STAFF RECOMMENDATION 2212 Grantland Avenue December 20, 2017

Application: New construction—infill and outbuilding
District: Woodland in Waverly Historic Preservation Zoning Overlay
Council District: 17
Map and Parcel Number: 10514010900
Applicant: Stephen Bock
Project Lead: Melissa Baldock, melissa.baldock@nashville.gov

Description of Project: Application is to construct duplex infill and an outbuilding. The outbuilding is not approved as a Detached Accessory Dwelling Unit.

SITE PLAN
 SCALE: 1/4" = 1'-0"

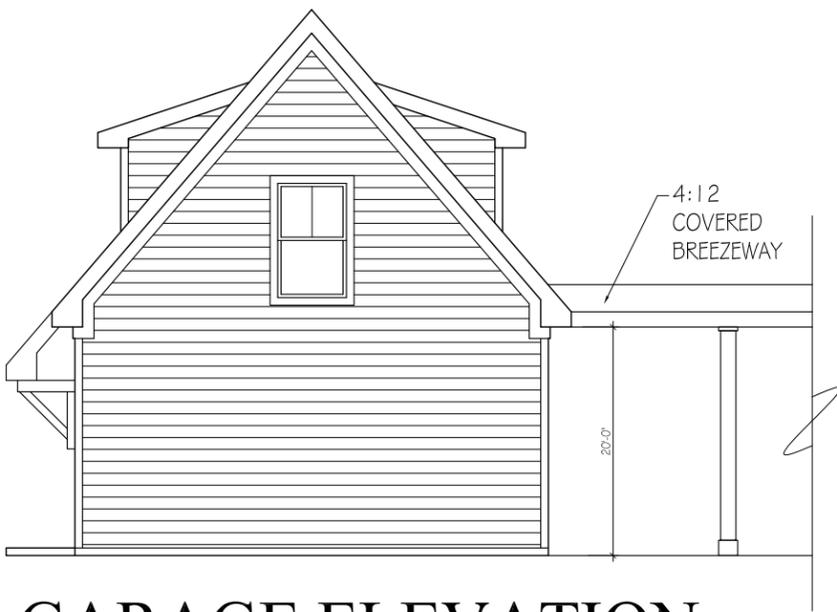
Setback and Rhythm of Spacing: The new infill meets the base zoning minimum setback requirements. The structure will be a minimum of nine feet, two inches (9'2") from the side property lines and forty-seven feet (47') from the rear property line. The front wall of the house will be approximately twenty-three feet (23') from the front property line, and the front porches will be approximately eighteen feet (18') from the front property line. This front setback is similar to the setback at 2214 Grantland and is a few feet back from the historic house on the other side at 2206 Grantland. Staff finds that the proposed front setback meets the historic context and the design guidelines. Staff finds that the project's setback and rhythm of spacing meet Section III.B.2.c of the design guidelines.

Orientation. The infill is oriented to face Grantland Avenue, which is appropriate. The duplex will have two, separate entrances facing Grantland Avenue. The entrances have two separate porches with depths of twelve feet, four inches (12'4"). The site plan did not show walkways leading from the sidewalk to the porches, and staff recommends that such walkways be added. Vehicular access to the site will be via the rear alley. With the condition that walkways be added from the sidewalk to the front porch, staff finds that the project's orientation meets Section III.B.2.f of the design guidelines.

1. Staff verify the construction height of the foundation and floor system in the field to ensure that the finished floor line of the new infill is compatible with the finished floor line of the historic houses on either side;
2. Walkways be added from the sidewalk to the two front porches;
3. The front doors be at least half glass, and staff approve all windows and doors prior to purchase and installation;
4. Staff approve a stone sample;
5. Staff approve the roof shingle color and texture;
6. Staff approved the material of the floors and steps for all porches;
7. Staff approve all appurtenances, including, but not limited to lighting, fencing, pathways, parking pads; and
8. The HVAC unit and other utilities be placed on the rear façade, or on a side façade beyond the midpoint of the house.

GARAGE ELEVATION

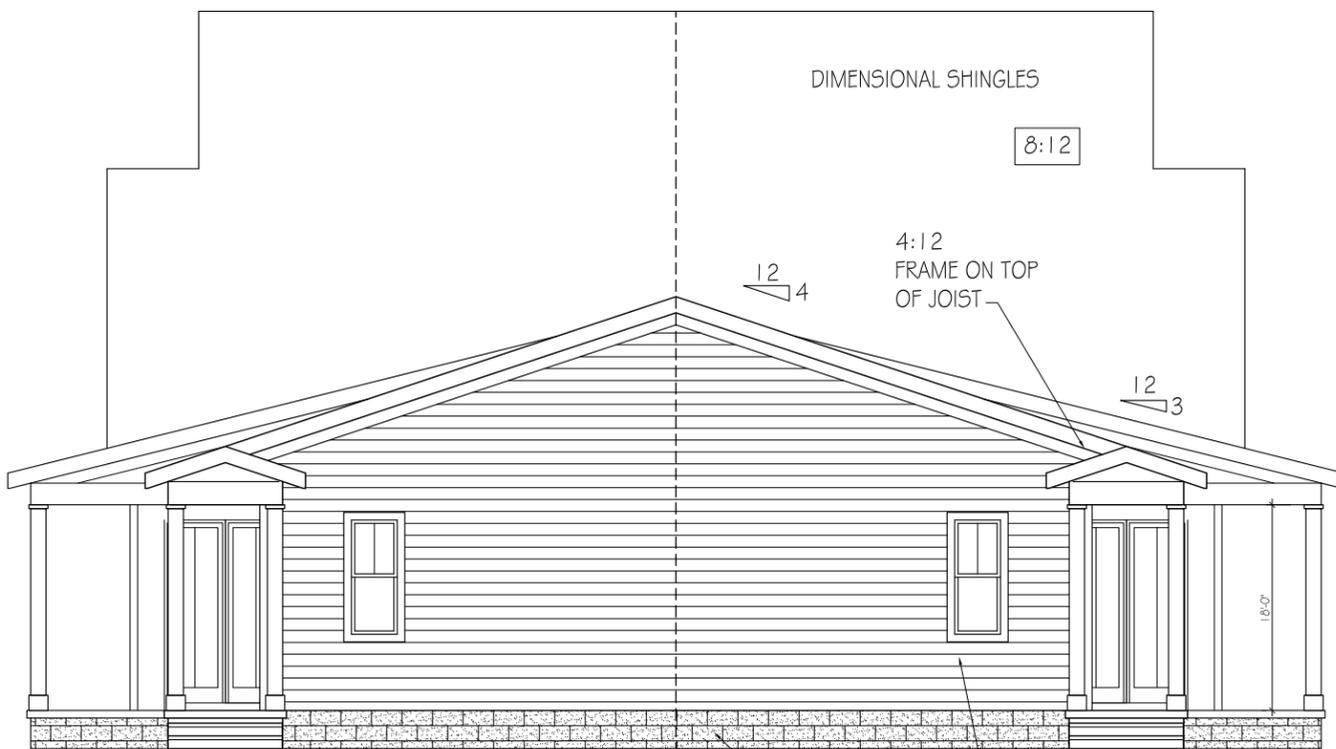
Outbuilding: The applicant proposed a one-and-a-half story outbuilding that will not be used as a dwelling unit. The outbuilding and the infill will be connected with covered breezeways that are four feet (4') wide and open on both sides. The Commission has approved such breezeways in the past.

Since the form and slopes are similar to historic outbuildings, staff finds that the project meets Section III.B.2.h.1 of the design guidelines.

Design Standards: The accessory structure has a simple, utilitarian design that is appropriate for outbuildings. Its roof form, detailing, and form do not contrast greatly with the primary structure. It is in a minimally-visible location at rear of the building. Staff finds that the outbuilding design meets section III.B.2.h.1 of the design guidelines.

With the staff’s final approval of the windows and doors and material information that has not yet been provided, staff finds that the known materials meet Section III.B.2.h. of the design guidelines.

FRONT ELEVATION

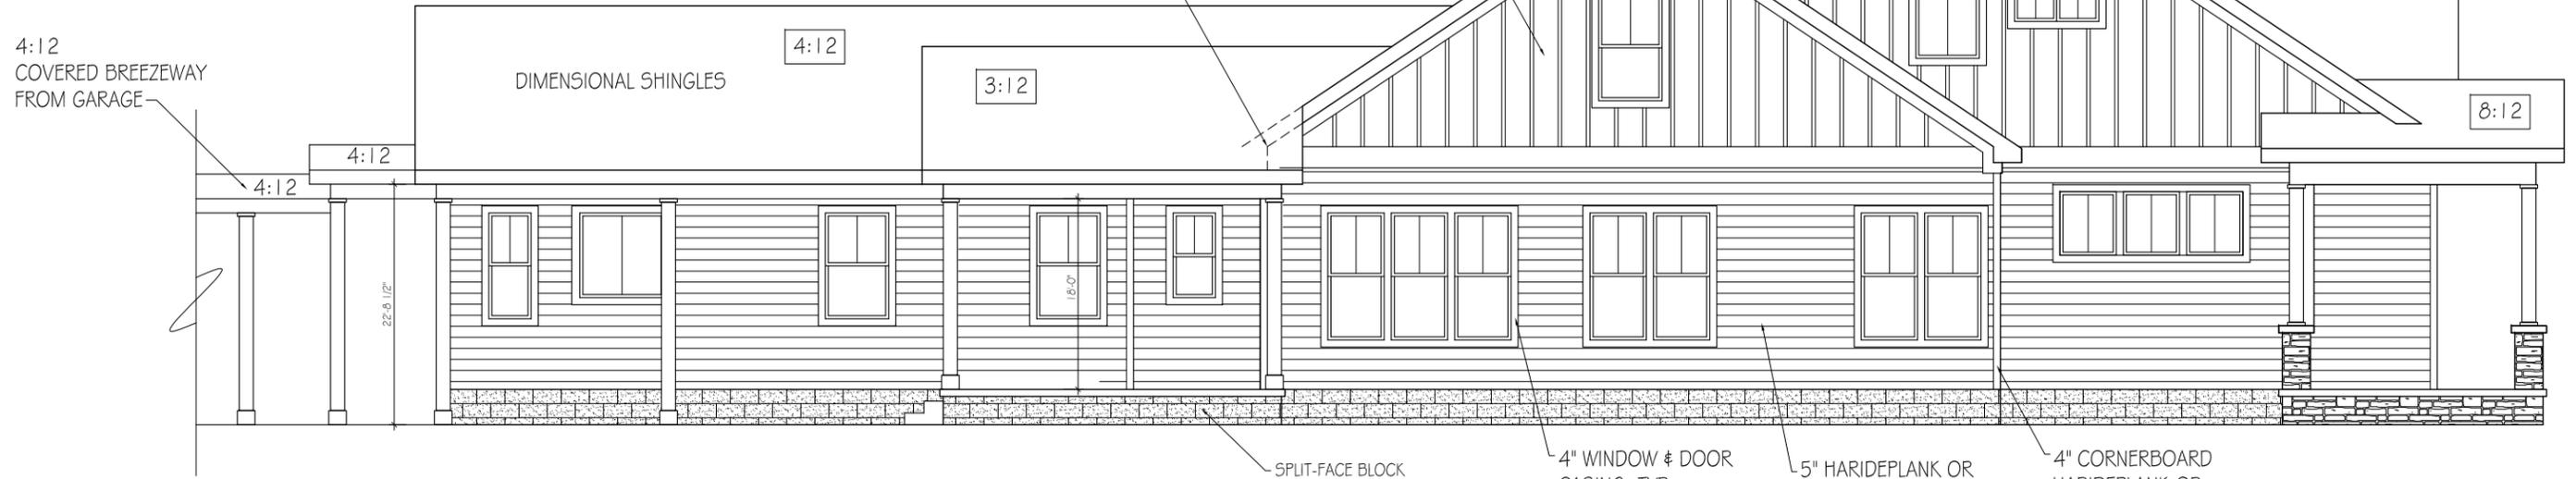
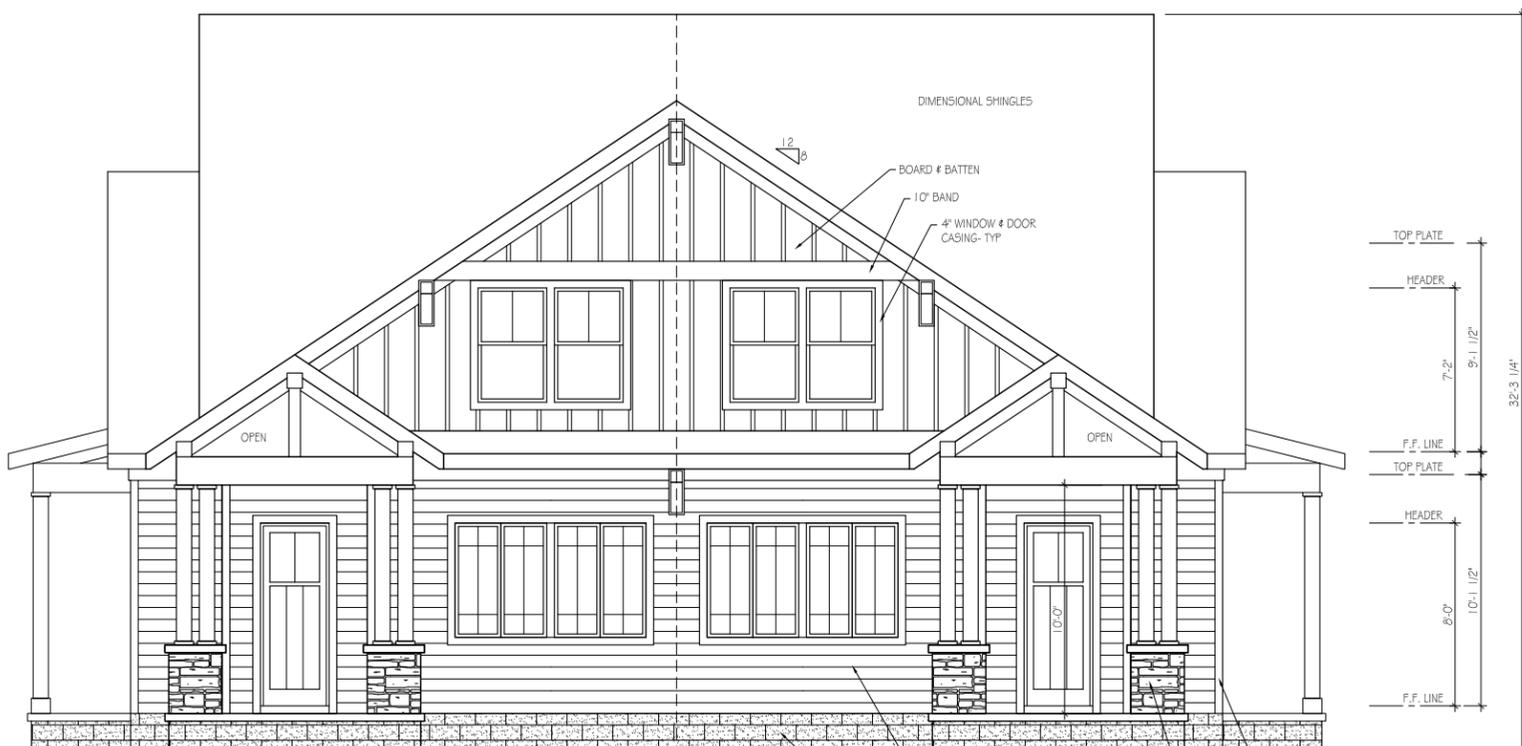
Height and Scale: The proposed infill will be one and one-half stories with an eave height of approximately twelve feet, six inches (12'6") above grade and a ridge height of thirty-two feet, three inches (32'-3") above grade. The foundation will be approximately eighteen inches (18") tall, and staff recommends that the constructed height of the

* The front doors are drawn as one-third glass, but the design guidelines state that new front doors should be at least one-half glass. Staff therefore recommends that the front

Roof Form: The house's roof is a cross-gable roof form with an 8/12 pitch. At the rear, the one story portions of the house have gable roofs with 3/12 and 4/12 pitches. The design guidelines state that roof pitches should be a minimum of 6/12. Staff, however, finds the lower roof pitches to be acceptable, in this instance, because they will not be highly visible from the street and will be located at the back of the house, over fifty feet (50') from the front of the house. Staff finds that the proposed roof forms are compatible with the surrounding historic roof forms, and meet Section III.B.2.e. of the design guidelines.

doors be at least one-half glass, and that staff approve all final door and window choices. Staff also recommends approval of a stone sample, the roof shingle color and texture, the materials for the porches' floor and steps, and all appurtenances. With staff's final approval of all material choices, staff finds that the known materials meet Section III.B.2.d. of the design guidelines.
